2FY20 K9 TRAINING CENTER - AMENDMENT 2

THIS AMENDMENT IS BEING PREPARED TO SUMMARIZE RESPONSES TO QUESTIONS THAT IMPACT THE BUILDING SPECIFICATIONS PREVIOUSLY OUTLINED.

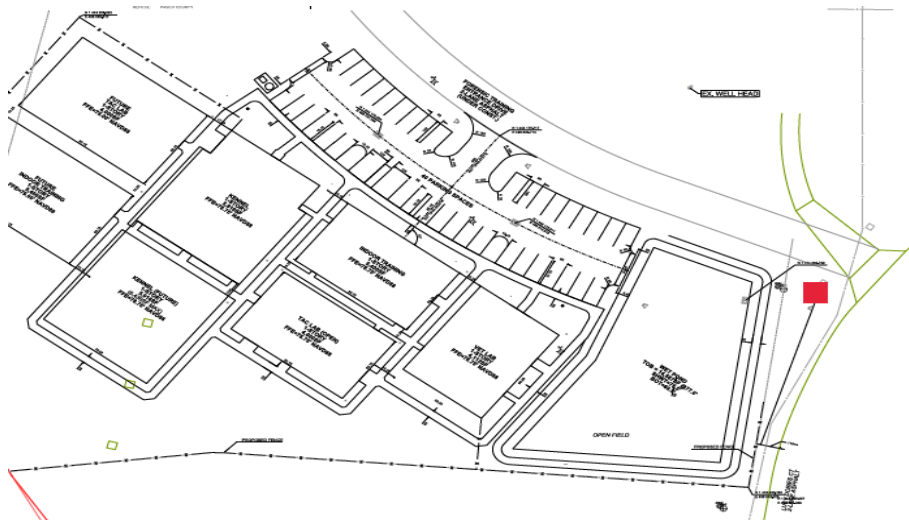
- THE PRIMARY POWER SUPPLY/TRANSFORMER IS INSTALLED IN THE NORTHEAST CORNER OF THE SITE. APPROXIMATE LOCATION INDICATED BELOW.
